RESOLUTION 2016-111

A RESOLUTION OF THE CITY COUNCIL OF NIXA, MISSOURI, APPROVING THE PRELIMINARY PLAT FOR THE IRISH HILLS SUBDIVISION

**REQUESTED ACTION:** Preliminary Plat Irish Hills

PRELIMINARY PLAT IRISH HILLS ESTATES

PRELIMINARY PLAT

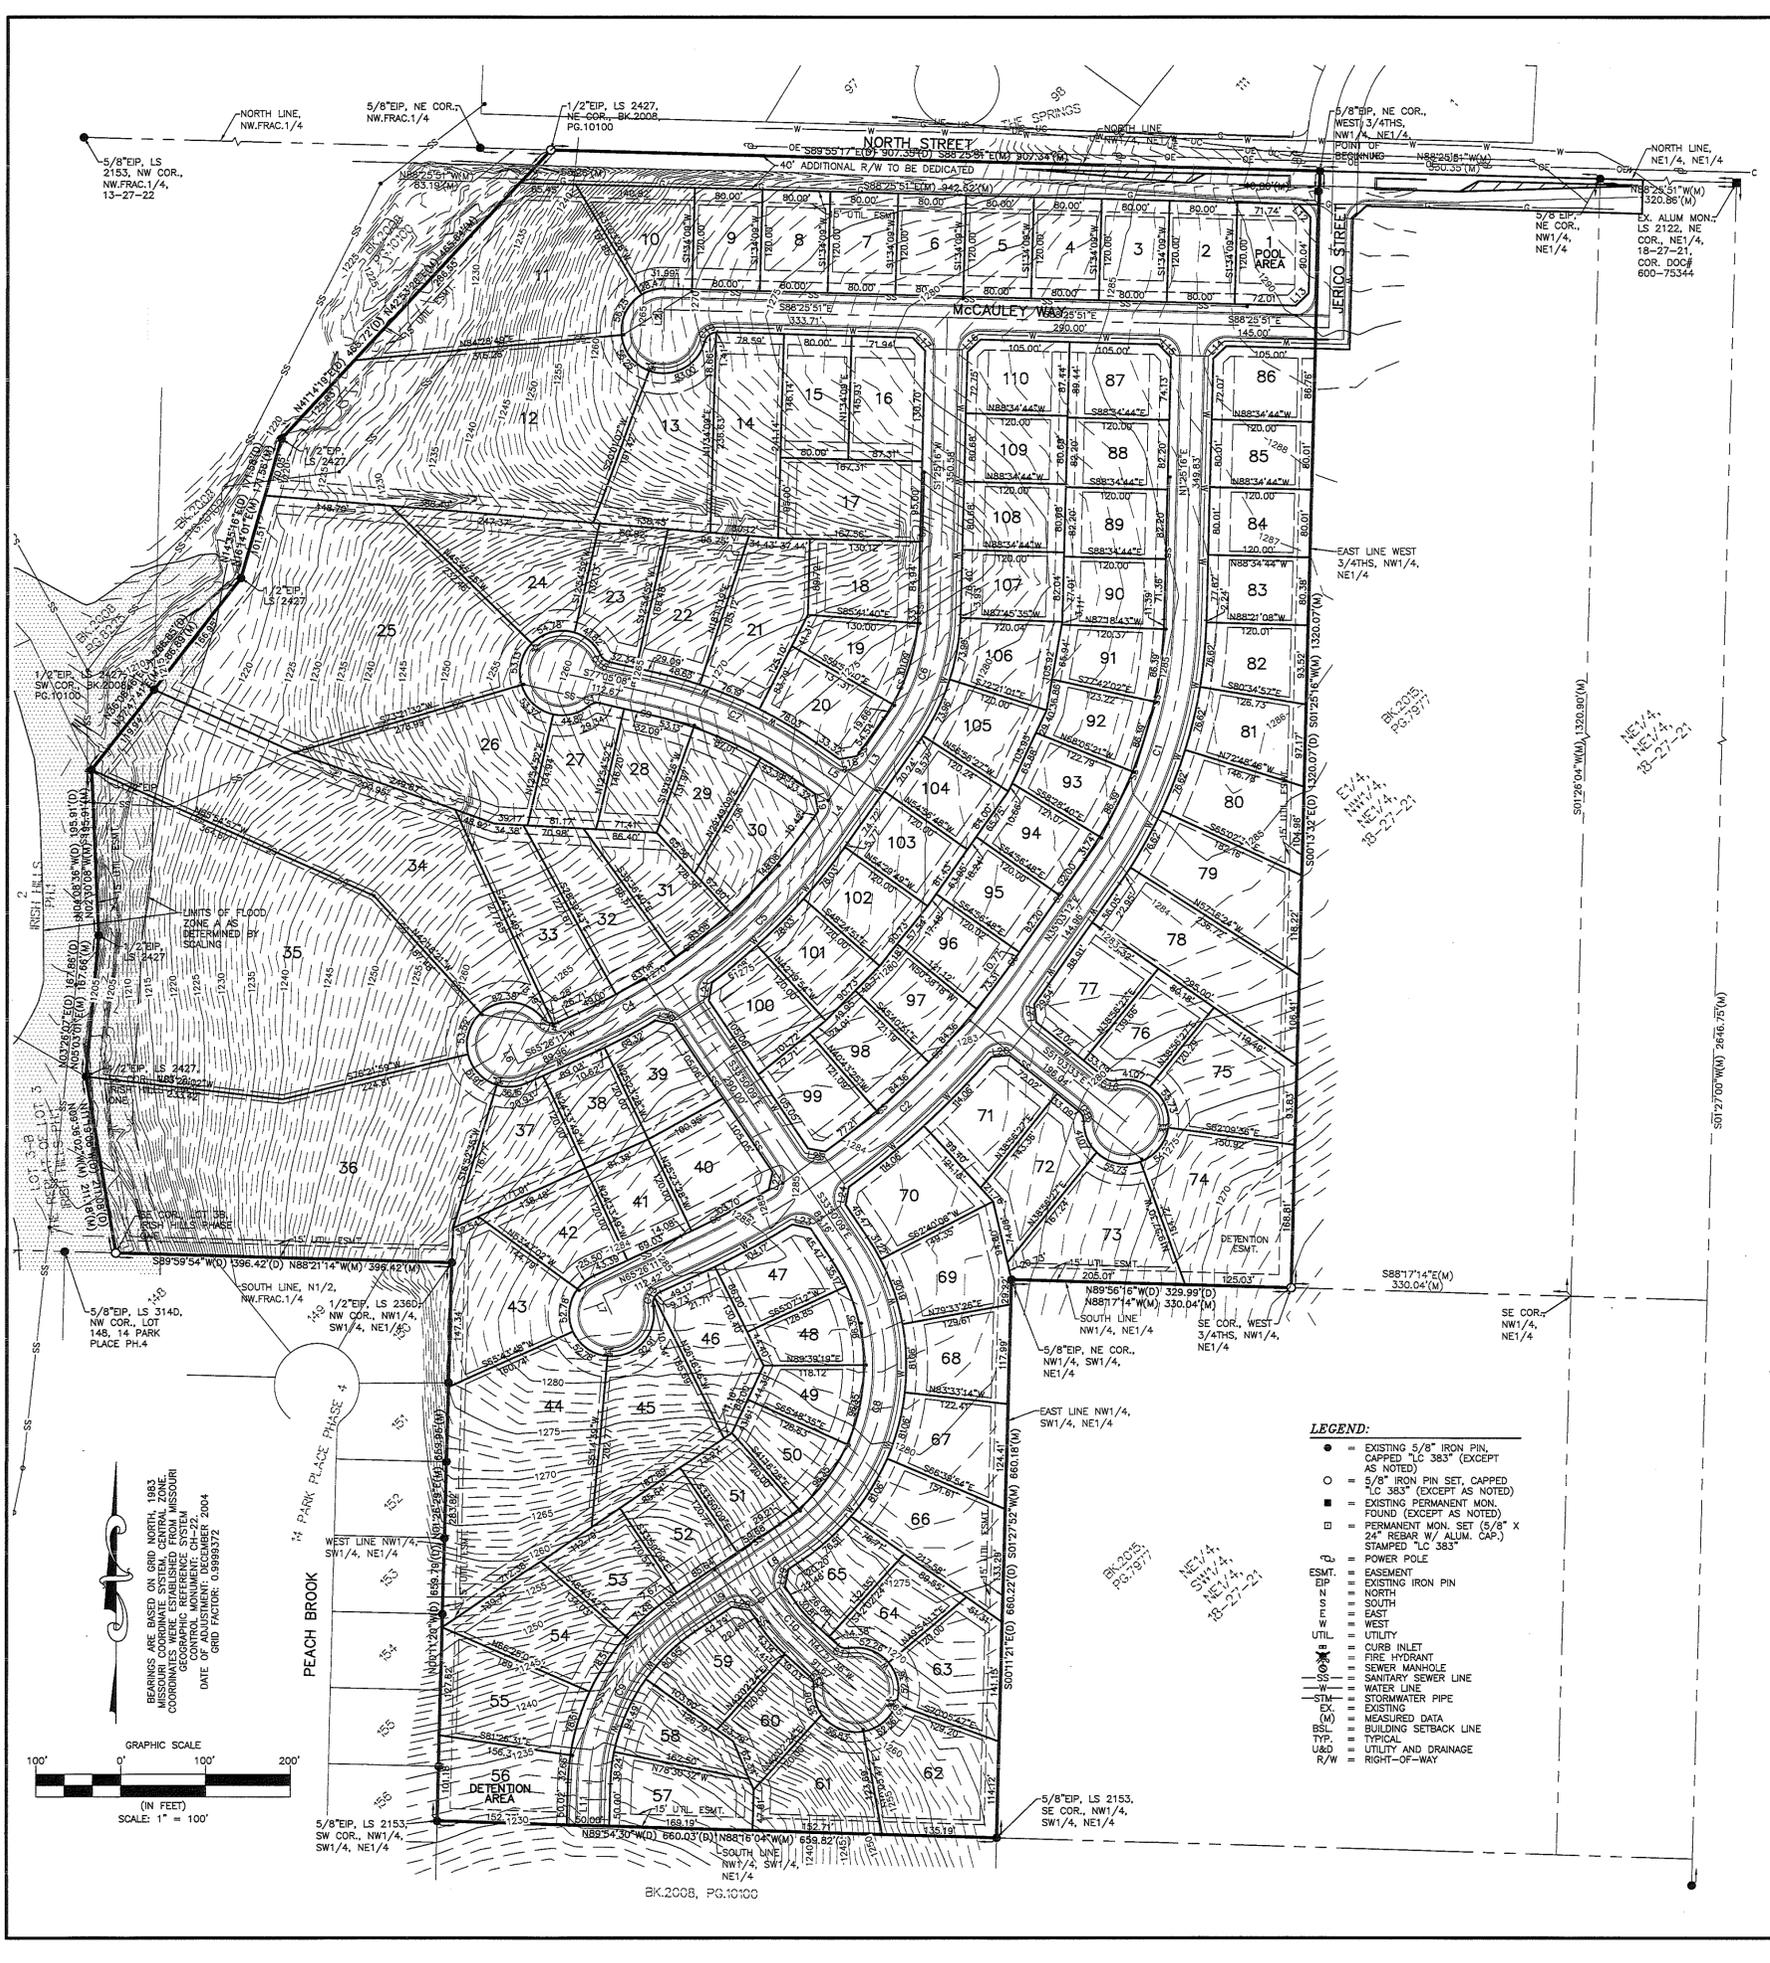
1. As shown on the preliminary plat and required in the Annexation Agreement, the applicant must provide 40 feet of R.O.W. from the center of North Rd. and will be responsible for complying with the Traffic Impact Study as prepared by CJW in compliance with the Collector Street Policy. The improvements will include widening North Rd. to Secondary Arterial status, with the installation of a center turn lane extending 100' either side of the intersection.

2. The proposed plat reflects one lot for a pool and one lot for a detention basin shown as common open space lots. The applicant is proposing the creation of a Home Owners Association for maintenance and upkeep of the open space areas. The HOA document must provide for maintenance and upkeep of the common areas as provided by Nixa City Code. Prior to recordation of the document the City must sign off on the language provided to ensure that maintenance is provided in perpetuity by the residents of Cheyenne Valley.

3. A FEMA identified floodplain is located along the west property line. Base flood elevations will need to be identified for those lots adjacent to the floodplain area.

4. Due to the FEMA floodplain and the extreme topography that the valley provides, staff is in support of a subdivision exception for the lot depths of lots 11, 12, 25,34, 35, and 36. As proposed the lots depth exceeds 2 ½ times the width. The extreme slope of the land along with the floodplain warrants the excessive depth of the lots to maintain a buildable area for a home.

5. No direct driveway access shall be provided on North Rd. All access to homes must be provided from the internal street system.
6. As provided in the engineers report, the applicant wishes to construct the development in phases. As proposed the development meets the subdivision regulations requirement for two means of access to the development with the entrance to North Rd. and the connection to Summit Meadows. If phasing of the site does not provide both access's in the initial phase, an emergency access must be provided. An existing emergency access exists north of the development in The Springs subdivision. The construction of an emergency access to Irish Hills must line up with the existing access to The Springs; this will necessitate its location between Lots 5 and 6 on the proposed plat.

7. Reverse corner lots shall not be provided. In circumstances where a lot has roadway adjacent to two sides of the lot the home shall front the lesser traveled of the streets unless otherwise dictated to provide for continuity to the street layout. Direction for

home placement shall be provided on the final plat as dictated by the City of Nixa in conformance with the subdivision regulations.

8. Sewer for this site shall be provided through the Northeast Regional Lift Station. Connection to the sewer system will necessitate that the applicant make payment to the City in accordance with adopted connection criteria established at the time of construction of the system.

9. The preliminary plat includes a combination of 30' wide and 27' wide streets. Streets constructed as 27' wide streets and shall only allow parking on one side of the street. To ensure that pedestrian site visibility is maintained, the no parking side of the street shall be coordinated with the side of the street that the sidewalks are required.

10. Street names and addressing of the phase will be coordinated with Christian County E911. It shall be the applicant's responsibility to provide E911 with all proposed street names to gain approval for their use.

11. The engineer must submit with the construction plans for streets and drainage a planned route for construction equipment and traffic access to the property.

12. Storm water will be transported through concrete ditches or in underground pipes to non-buildable areas that meet the 100-year storm requirements and other requirements of the city's Technical Specs Manual.

13. A fee-in-lieu of detention is being proposed for a portion of the site. The submitted storm water drainage plan will need to provide the necessary study to provide compliance with the requirements for use of the fee-in-lieu of program. The information provided shall be reviewed and approved by the City's storm water engineer prior to acceptance of the request for fee-in-lieu of.

14. In accordance with the subdivision regulations, it will be the engineer's responsibility at the end of each phase and prior to signing of the final plat or release of security bonding, to provide the city with a stamped and sealed set of as-builts, as well as, a copy of the construction plans and final plat on disc.

15. Obtaining water and sewer service is the responsibility of the applicant. Any easements or dedication of land necessary to obtain connections meeting the City's adopted connection criteria are also the responsibility of the applicant.

16. Erosion control measures must be implemented during all phases of construction to avoid siltation build-up in drainage areas. This will include hay bale barriers, silt fences or other erosion control measures where needed. If initial erosion control measures are washed out or damaged, it will be the developer's responsibility to replace and improve these efforts. The developer will be responsible for cleaning debris from drainage channels if they become blocked or clogged.

17. All storm water produced by this development must be diverted to detention basins that are sized to handle the 100-year storm and must be constructed in accordance with city specifications.

18. Fire hydrants are required to be located every six hundred feet as well as at the end of all cul-de-sacs throughout the development.
19. Sidewalks are required to be constructed on the side of the street that the water line is placed. All sidewalk infrastructure must be in place along with all other public improvements prior to recordation of the final plat.

20. When recorded, the final plat must include a 15' utility easement along the rear of all perimeter lots. Also, a 10' utility easement will need to be located between lots as required for the placement of streetlights. The City's electric superintendent will inform the developer where the easements are to be placed prior to recording of the final plat.
